GOVERNMENT OF THE DISTRICT OF COLUMBIA  
DEPARTMENT OF TRANSPORTATION

**MEMORANDUM**

**DATE:** January 9, 2017

**SUBJECT:** ZC Case No. 06-14D – Washington Gateway Phase 2 and 3 Modification

Figure 1 Bicycle Lobby (Source: MRP)

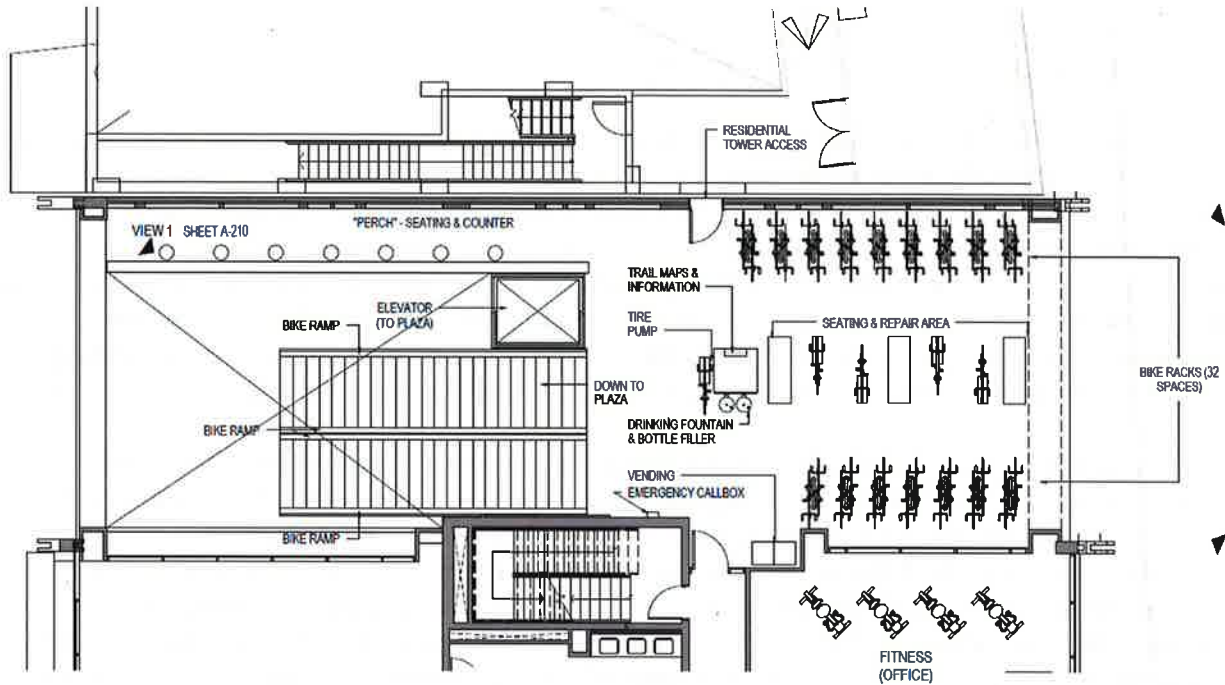
- **Stair slope:** The proposed interior staircase features a staircase featuring 6.5" risers and 14" treads (46% slope). The Applicant should install a staircase with a slope of 34% or less subject to DDOT approval.

- **Bike ramp design:** The specific design of the bicycle ramp is not provided. The Applicant should select a design that reflects best practices for accommodating bicycles on staircases subject to DDOT approval.

- **Elevator design:** The proposed elevator dimensions are not provided. The elevator should be "oversized" to satisfy the ZC Case No. 06-14 conditions to easily accommodate at least two bicycles with both wheels on the ground at a time.

- **Internal walkway widths:** Dimensions are not provided for the widths of the internal walkways between the bicycle repair area and the bicycle parking area at the upper lobby level. These walkways should be at least 8' wide to facilitate circulation. The Applicant may consider repositioning or relocating the short-term bicycle parking spaces to create wider walkways.

- Revise the bicycle lobby design to include the following elements:
  - Stair slope: Install a staircase with a slope of 34% or less subject to DDOT approval.

- Bicycle ramp design: Select a design that reflects best practices for accommodating bicycles on staircases subject to DDOT approval.
  - Elevator design: Install an “oversized” elevator to satisfy the ZC Case No. 06-14 conditions to easily accommodate at least two bicycles with both wheels on the ground at a time.

- Internal walkway widths: Design the internal walkways to be at least 8’ wide to facilitate circulation.
- Provide at least an 8’ wide temporary bicycle connection between the MBT and Florida Avenue if the North and South buildings are not constructed at the same time.
